Accessibility Design Review Report

Project Title: Forestville RSL Club and ILU development
22 Melwood Ave, Forestville

Job Number: 24125

Report Version: 24125_ADR_v1.3

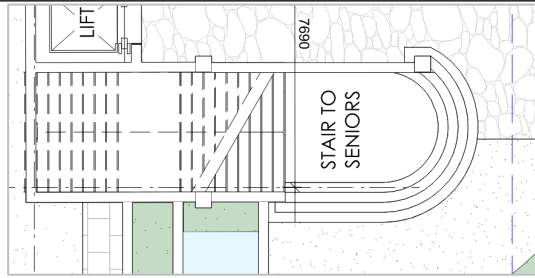
<p><u>Accessible Parking</u></p> <p>Accessible parking is proposed within the basement levels and on ground level, accessed via passenger lifts and pedestrian pathways.</p> <p><u>Principal Pedestrian Entrances (Building)</u></p> <p>Revolving doors are proposed to the Ground floor of the Club Building. While revolving doors are technically not accessible, the provision of a swing door as part of the overall 'doorway' likely makes these scenarios DtS compliant. If it is later determined not to be, a Performance Solution can be pursued to address the configuration.</p>	
--	--	--

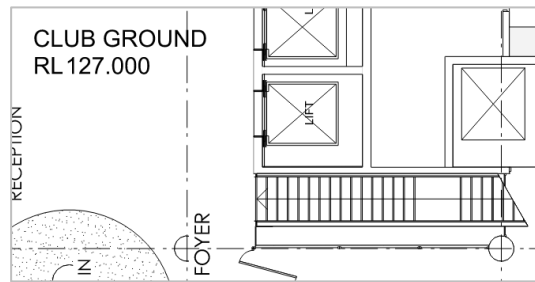
e.g. curved Stair to Seniors will require detailed design to ensure compliance.

e.g. Club GF lobby

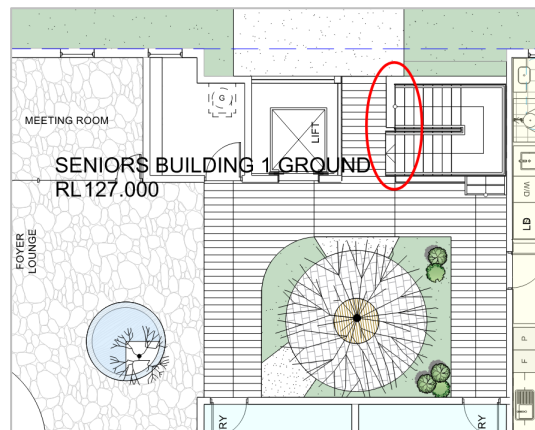
Ensure handrail extensions are provided at top and bottom landings of non-fire isolated stairways and setback/protected by a wall or similar in accordance with AS1428.1-2009.

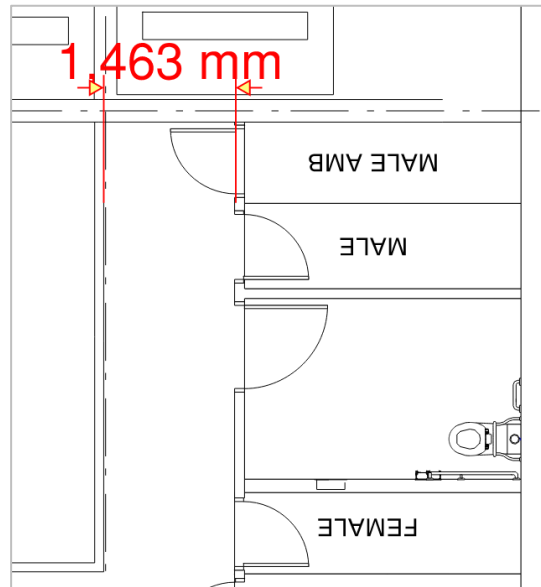
E.g. - Stairways within Seniors buildings to be developed.

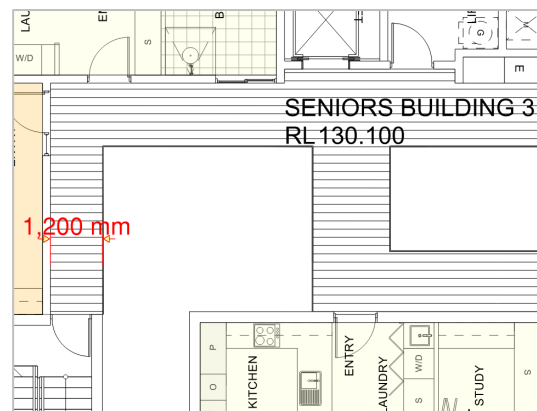
Ensure 180° turning (2070mm x 1540mm) space and is provided within 2m of a termination or at maximum 20m intervals along any new or altered accessways.

Ensure passing (2000mm x 1800mm) space and is provided at maximum 20m intervals along any accessways where there are obstructed lines of sight along any new or altered accessways.

A Performance Solution will be required for reduced turning spaces within Seniors building 3 common area corridors.

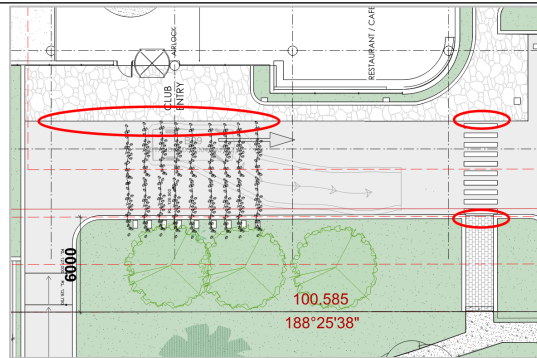
DtS Provision	Comment(s)/Recommendation(s)	Status
<p>Tactile ground surface indicators complying with sections 1 and 2 of AS1428.4.1-2009 must be provided to warn people who are blind or have a vision impairment that they are approaching –</p> <ul style="list-style-type: none"> • a stairway, other than a fire-isolated stairway; • an escalator/moving walk; • a ramp other than a fire-isolated ramp, step ramp, kerb ramp or swimming pool ramp; • in the absence of a suitable barrier an overhead obstruction less than 2 m and where an accessway meeting a vehicular 	<p>Compliance is readily achievable with minor design development and/or specification to BCA & AS1428.4.1-2009 at the Detailed Design Stage.</p> <p><u>Design Detail</u></p> <p>TGSIs will likely be required to identify the transitions between the pedestrian accessways and the vehicle carriage way in front of the club building.</p>	CoC

Ensure all integrated TGSIs (tiles) have a minimum 30% luminance contrast to the ground surface they are fixed to.

Ensure TGSIs are provided to non fire-isolated stairways and ramping between 1:14 to 1:20.

TGSIs are required at every stairway/ ramp landing where either 1 or both handrails are not continuous. Either provide continuous handrails or TGSIs at all landings with a discontinuous handrail.
